To: Jamie Bock, Dustin Crumb, Berend Winter, Chris Brockley-Blatt, John Coker, Lionel Duband
CC: Jerry Lillienthal, Bruce Swinyard, Peter Hargrave, Iris Didschuns, Matt Griffin
RE: BDA Thermal Control Hardware
Thursday 11, October 2001

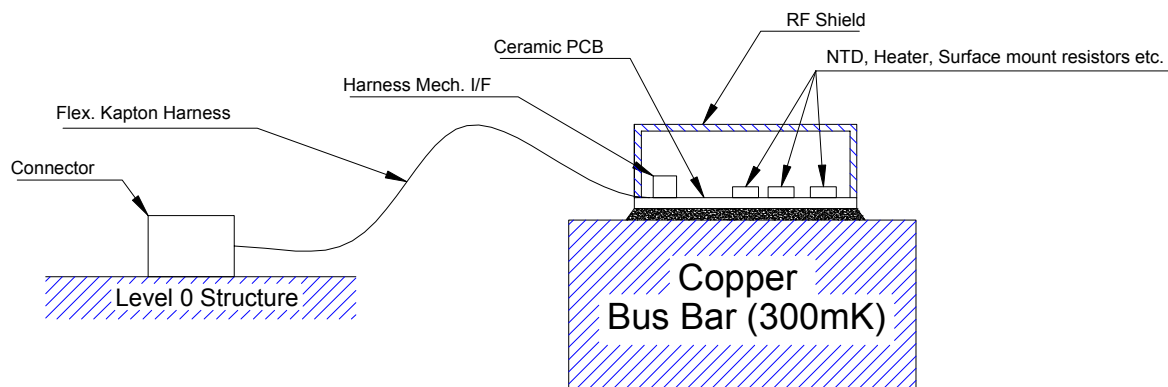
One possible means of reducing the mass would be to mount BDA TC Hardware as shown below.

- The 300-mK hardware could be mounted on a ceramic PCB that has been brazed to the Copper.
- Since it is not inside a BDA, it will require RFI shielding in the form of a metal cover over the PCB and metalised ground planes above and below the signal traces on a multi-layer Kapton harness.
- Surface mount resistors could be used for the heaters and NTD bias resistors to minimise volume (and mass).
- The prime and redundant components would be mounted on a single PBC/Harness.

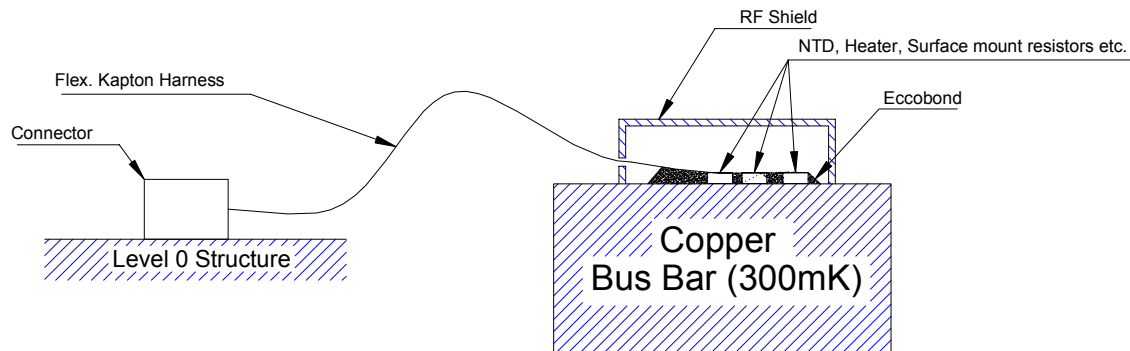
Another concept would be the surface mounting of the electrical components directly onto the Kapton harness and then bonding this directly in contact with the Copper then covering the end of the harness with a RF shield as illustrated below.

Could JPL and MSSL please comment on these assertions and on the design proposals. Lionel, do you have any pearls of wisdom to add to the discussion?
